ARLINGTON COUNTY, VIRGINIA

County Board Agenda Item Meeting of September 17, 2005

SUBJECT: Adoption of proposed amendments to Section 20 (Appendix A) "CP-FBC"
Columbia Pike - Form Based Code Districts of the Zoning Ordinance to:

ORDINANCE TO AMEND, REENACT, AND RECODIFY ZONING PROVISIONS OF THE ARLINGTON COUNTY ZONING ORDINANCE, SECTION 20. "CP-FBC" COLUMBIA PIKE FORM BASED CODE DISTRICT [APPENDIX A.] TO DEFINE DEVELOPMENT OPTIONS, INCLUDING MODIFICATIONS TO DEFINITIONS, STREETScape STANDARDS, AND ARCHITECTURAL STANDARDS.

B. Building Envelope Standards: Main Street Sites

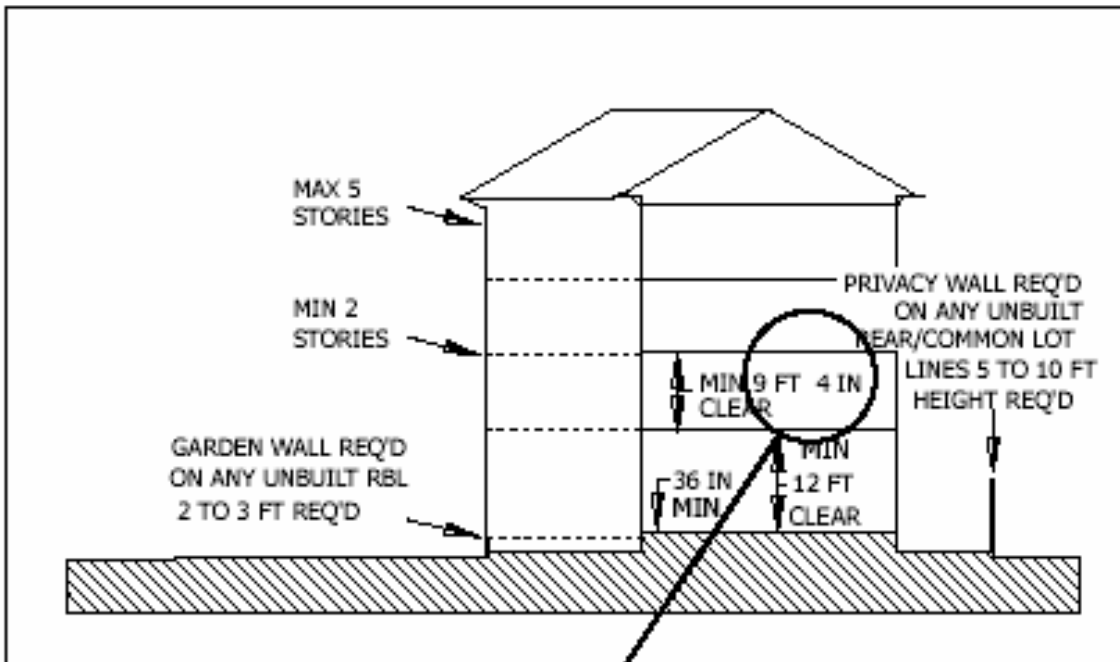
Proposed change: 9 feet clear for upper STORIES except uppermost STORY which shall have a minimum clear height of 10 feet.
